Additional Information Response
DUB11 CAMPUS DEVELOPMENT
Design Statement in support of
Planning Application

DUB11-DC-XX-G021-V1-PL-BMD

Revised Feb 28th, 2022

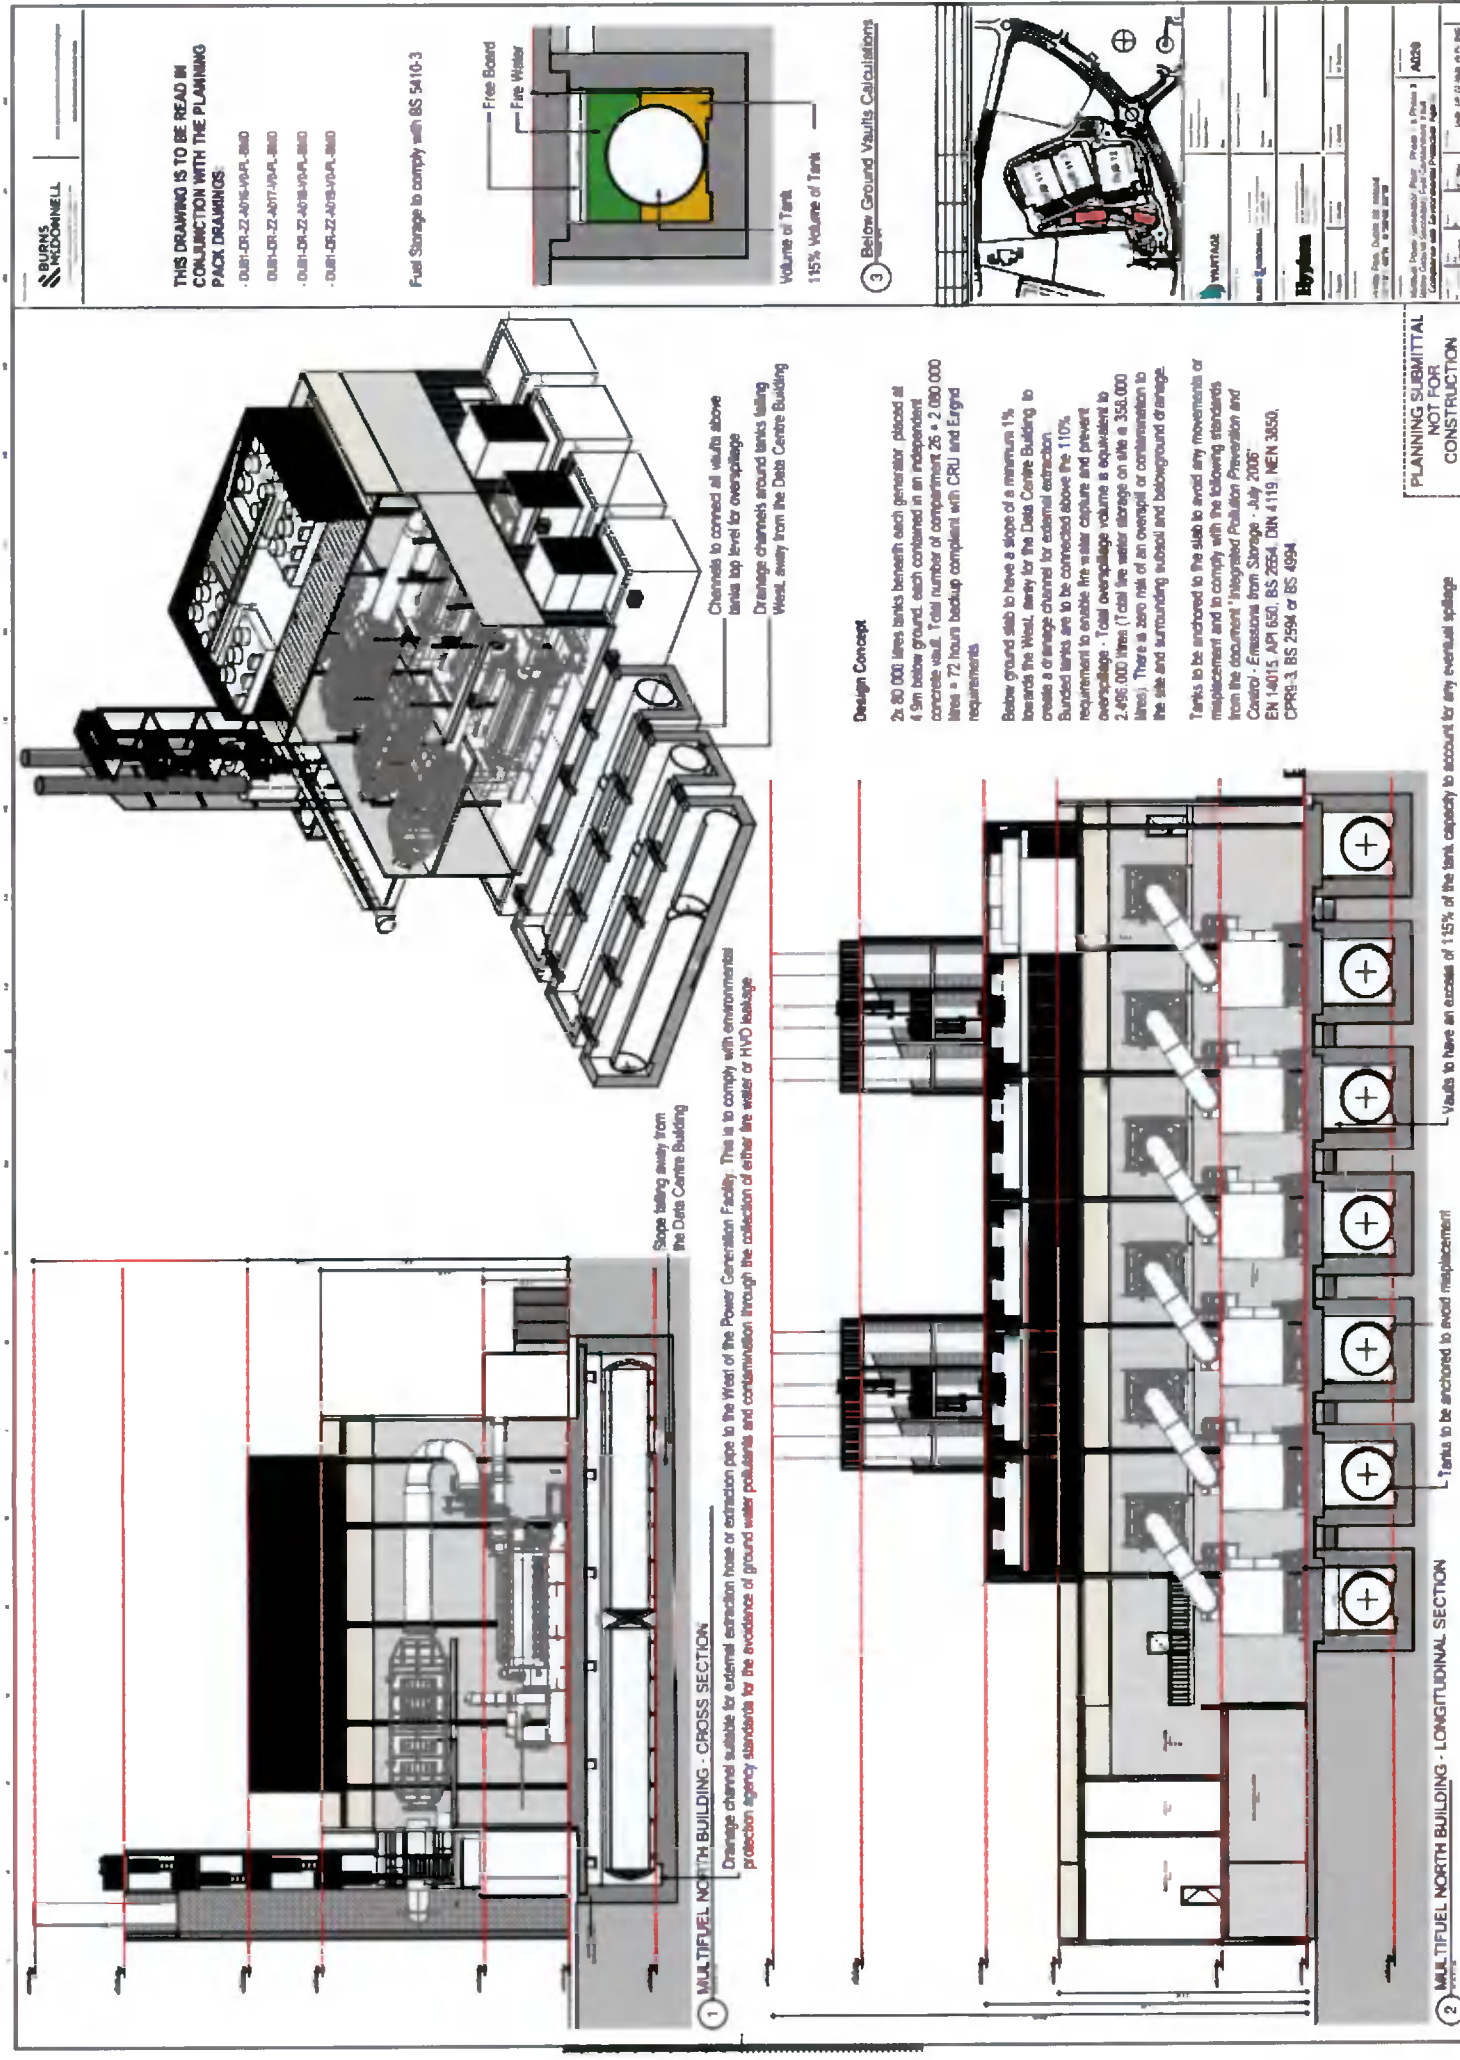
(f) The diesel-powered electrical generators located to the immediate west are housed on site in a screened equipment yard located adjacent to the building and separated by an internal road. The applicant states the usage is only to supply power in the event of a utility outage. The Planning Authority would request further details and cross-sectional views on the stated 'buried' fuel tanks shall only be used where sub-base tanks are prohibited.

The original design included an electrical yard to the west of the datacentres housing containerised generators each with integral "belly tanks". As part of the exercise to make the campus more compact this compound has been re-designed to reduce the footprint of the yard by double-stacking the generator sets. In addition, the generators are placed at an angle to the building and the flues moved up against the west facade. There is an air exhaust at the west end of each generator to eject heat from the engines. These flues are clad in powder-coated metal in alternating light and mid-grey colours to add some visual interest to this side of the buildings and obviate a flat wall of exhausts. The chimney height is 20 metres. Refer to Drawing DUB1-DR-00-A116-V0-PL-BMD

Fuel is stored in above-ground tanks in the base of the genset containers.
